## **Proposal for Supplement 6 to the 01 series of amendments to UN Regulation No. 129 (Enhanced Child Restraint Systems)**

### **Submitted by the Working Party on Passive Safety\***

## Supplement 6 to the 01 series of amendments to UN Regulation No. 129 (Enhanced Child Restraint Systems)

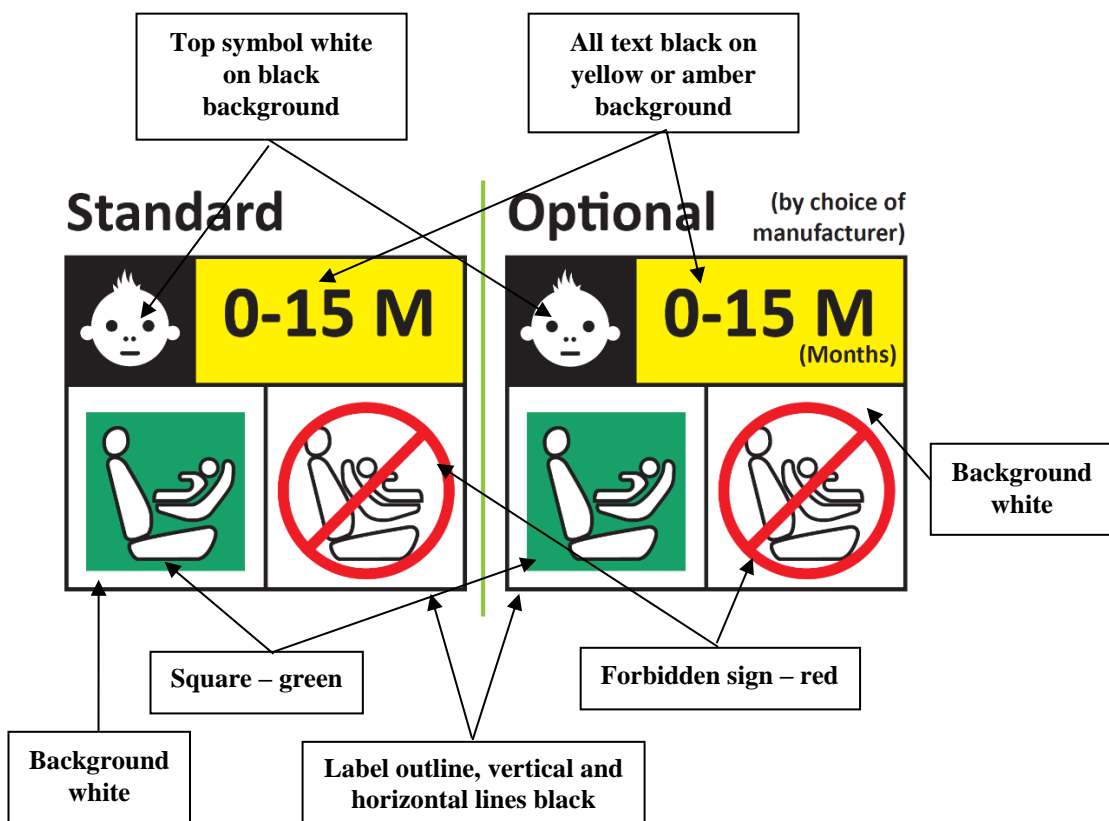
Paragraph 4.5., amend to read:

"4.5. Integral Enhanced Child Restraint Systems that can be used forward and rearward facing, shall have the following label permanently attached on the part hosting the child and visible to the person installing an Enhanced Child Restraint System in the vehicle:

The manufacturer shall be permitted to include the word "months" to explain the symbol "M" in the label. The word "months" should be in a language commonly spoken in the country or countries where the product is sold. More than one language is allowed.

Minimum label size 40 x 40 mm

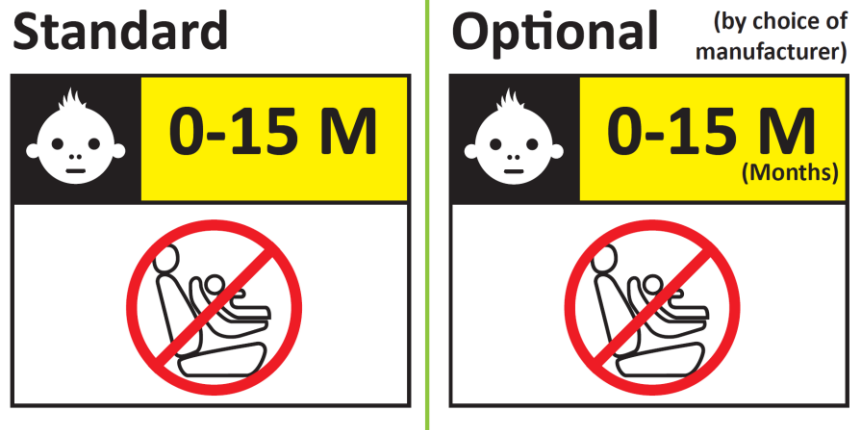
Integral Enhanced Child Restraint Systems that can be used forward facing only shall have the following label permanently attached on the part hosting the child and visible to the person installing an Enhanced Child Restraint System in the vehicle:

The manufacturer shall be permitted to include the word "months" to explain the symbol "M" in the label. The word "months" should be in a language commonly spoken in the country or countries where the product is sold. More than one language is allowed.

Minimum label size 40 x 40 mm
